**Marion County
Board of County Commissioners**

**PLANNING & ZONING SECTION
STAFF REPORT**

Public Hearings	P&Z: 1/26/2026	BCC: 2/17/2026
Case Number	260207ZP	
Application Number	PL PUD-000131-2025	
Type of Case: Rezoning for PUD Modification	FROM: Planned Unit Development (PUD) – RV Park with private amenities TO: Planned Unit Development (PUD) – RV Park with public amenities with limited increased height allowance to 145' for waterslide amenity (only).	
Owner	8M Holdings, LLC.	
Applicant	Fred N. Roberts, Jr., Esq. Klein & Klein, PLLC.	
Street Address / Site Location	18365 NW 45 th Avenue Road	
Parcel ID Number(s)	02781-000-00	
Property Size	140.91 acres	
Future Land Use	Commercial	
Zoning Classification	Planned Unit Development (PUD)	
Overlay Zones / Special Areas	Outside the Urban Growth Boundary (UGB), In Farmland Protection Area (FPA); Orange Lake Environmentally Sensitive Overlay Zone (ESOZ), County-wide Secondary Springs Protection Overlay Zone (S-SPOZ), Marion County Utilities NW Regional Service Area

Figure 7 – Prior PUD Concept Plan Excerpt with Proposed Revisions

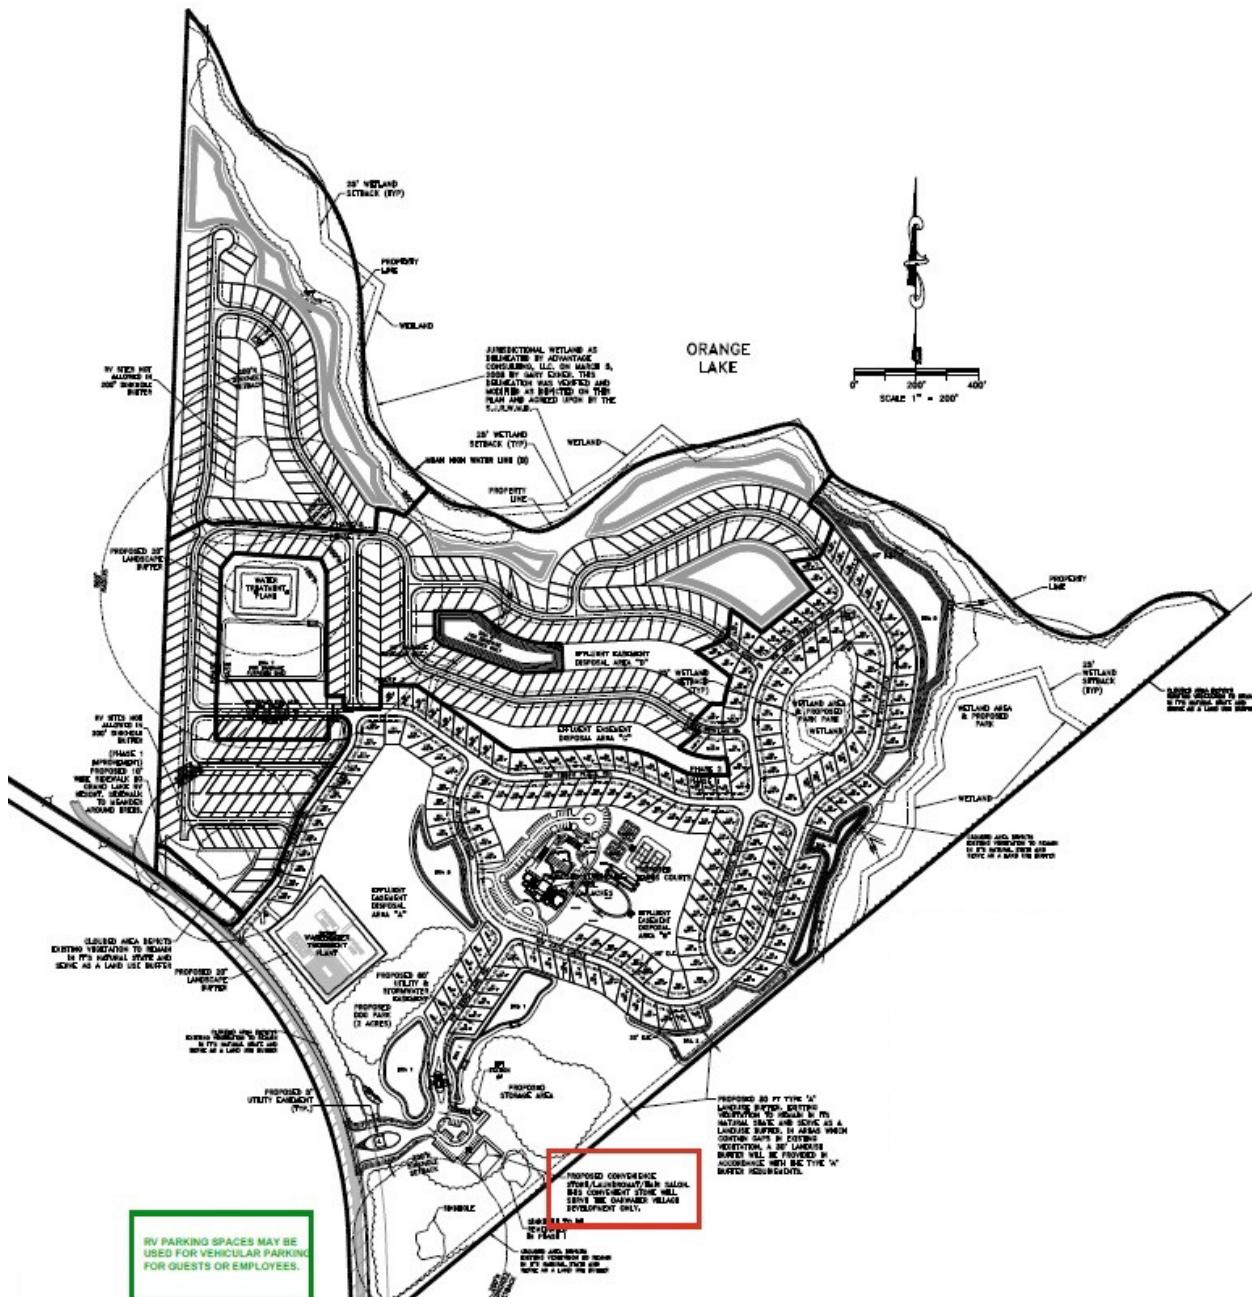
- 1) Delete: "*PROPOSED CONVENIENCE/STORE/LAUNDROMAT/HAIR SALON. THIS CONVENIENT STORE WILL SERVE THE OAKWATER VILLAGE DEVELOPMENT ONLY*" and
- 2) Add: "*RV PARKING SPACES MAY BE USED FOR VEHICULAR PARKING FOR GUESTS OR EMPLOYEES.*"

The proposed text changes are reference in Figure 7 below with the red identifying the deleted language and the green indicating the added language. Further the PUD Conceptual Plan reflecting these changes is provided as Attachment B, followed by the project's ongoing approved Major Site Plans as Attachments C and D.

A final adjustment is requesting enabling a PUD height increase for the recreational slide system components west of the pool area, planned area, increasing the height allowance from 40-feet to 145-feet while maintaining the remainder of the PUD's height limit at 40-feet for all other structures (e.g., clubhouse, maintenance building, park models, etc.). The

4. The PUD's height limits shall remain as established; however, the pool slide complex consisting of four (4) slides and their access tower shall be allowed to extend up to a maximum of 145-feet.
5. PUD site must comply with the County's LDC lighting standards that require lighting be shielded so as to not cast direct lighting off-site and a photometric plan be provided during major site plan review to ensure no negative impacts to neighboring parcels.
